# SERVICE BULLETIN

SERVICE BULLETIN		No.: MSB-97E33-001	
		Date: 1997-11-24	
<b>Subject:</b> ADDITION OF HIGH GROUND-CLEARANCE SUSPENSION			<b>&lt;Model&gt;</b> ALL MODELS
<b>Group:</b> FRONT SUSPENSION			<b>&lt;M/Y&gt;</b> 97-10
<b>INFORMATION</b>	OVERSEAS SERVICE DEPT	<i>R. Usami</i> R. USAMI - MANAGER QUALITY INFORMATION ANALYSIS

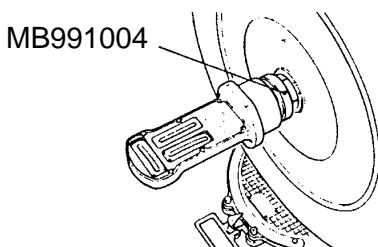
Items	Standard value
Toe-In	At the centre of tyre tread mm
	Toe-angle (per wheel)
Toe-out angle on turns (inner wheel when outer wheel at 20°)	22° , 0°10' ± 30'* <b>&lt;Added&gt;</b>
Camber	0°00' ± 30' (difference between right and left wheel: less than 30')
Caster	4°20' ± 1°30' (difference between right and left wheel: less than 30')
Kingpin inclination	7°20' ± 1°30'
Upper arm ball joint rotation starting torque Nm	0.3 - 1.5
Compression lower arm ball joint rotation starting torque Nm	0.5 - 2.5
Lateral lower arm ball joint rotation starting torque Nm	1.5 or less
Stabiliser link ball joint turning torque Nm	0.5 - 1.5

\*: High ground-clearance suspension

**<Added>**
